ORIGINATION FORM

Proposed Revisions to a Standard Plans Index

Index Number: 455-054
Sheet Number (s): 1
Index Title: 54" Precast/Post-Tensioned Concrete
Cylinder Pile

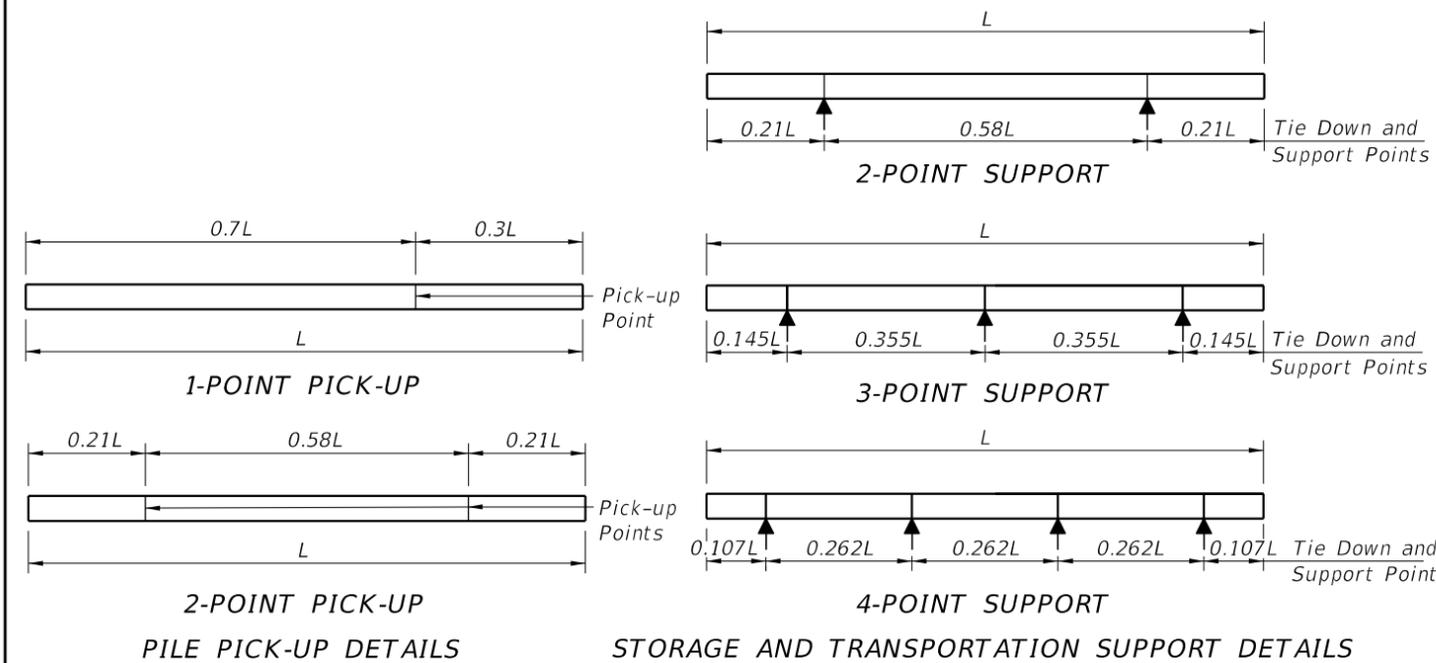
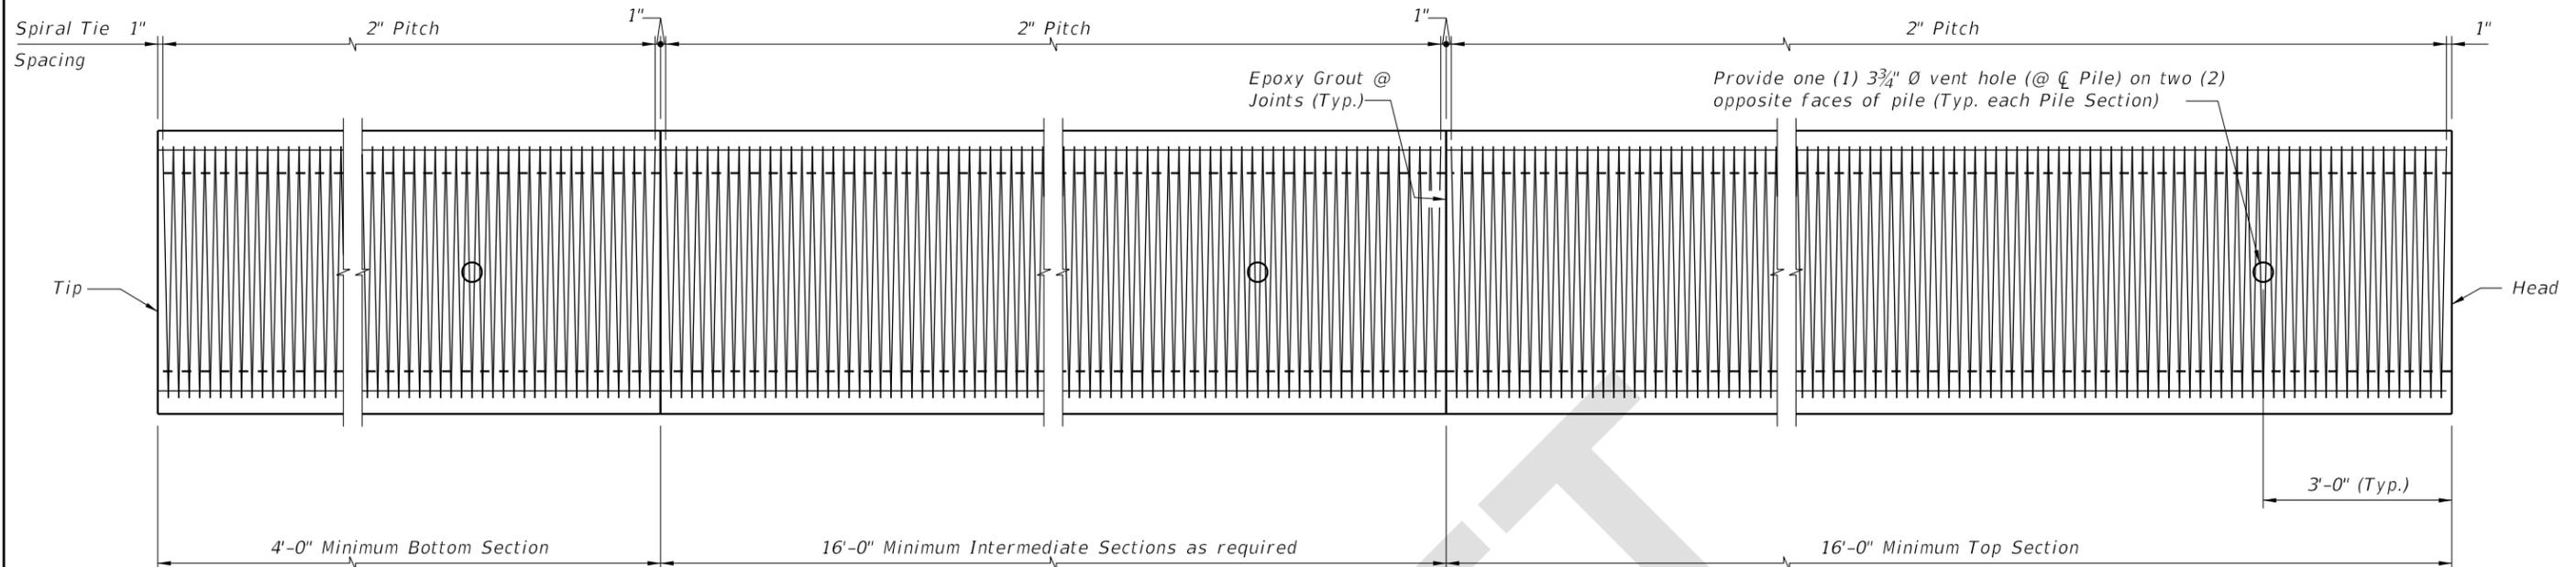
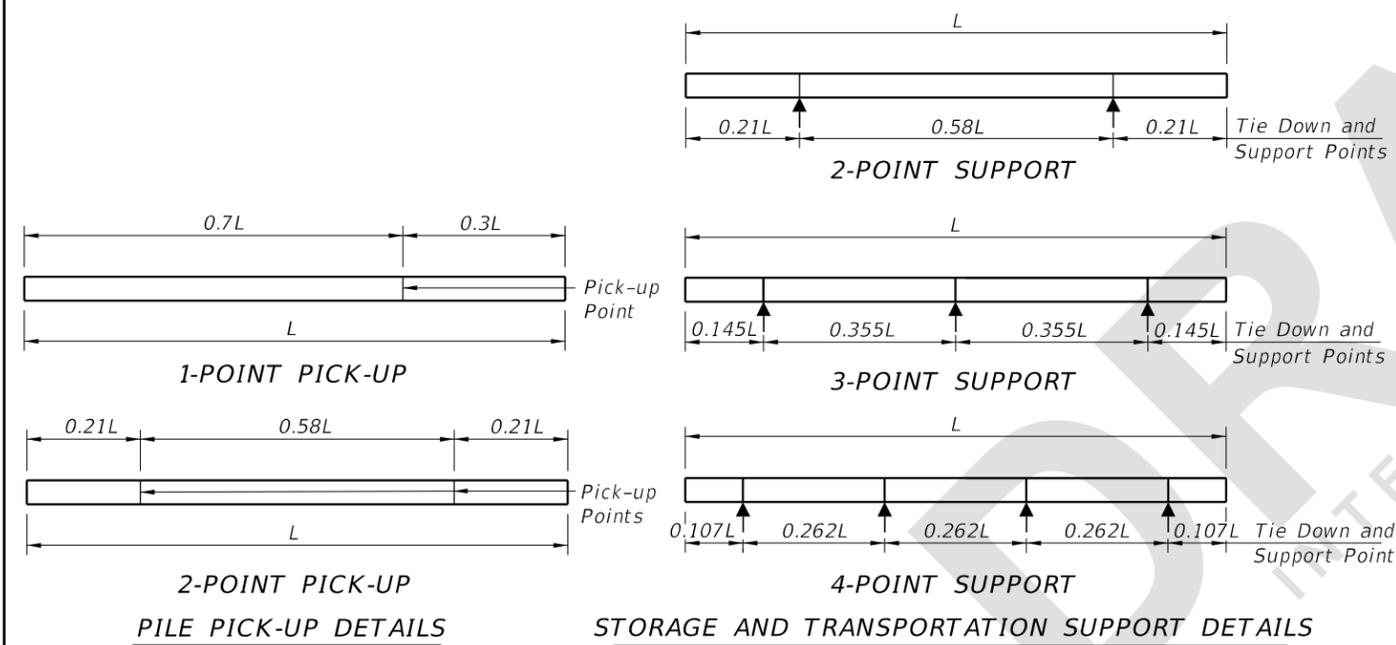
Changed Class V (Special) concrete to Class V.

- Work this Index with the Pile Data Table in the Structures Plans.
- Concrete:
 - Piles: Class V ~~(Special)~~
 - Splice: Class IV.
 - See "GENERAL NOTES" in Structures Plans for locations where the use of Highly Reactive Pozzolans is required.

- Work this Index with the Pile Data Table in the Structures Plans.
- Concrete:
 - Piles: Class V.
 - Splice: Class IV.
 - See "GENERAL NOTES" in Structures Plans for locations where the use of Highly Reactive Pozzolans is required.
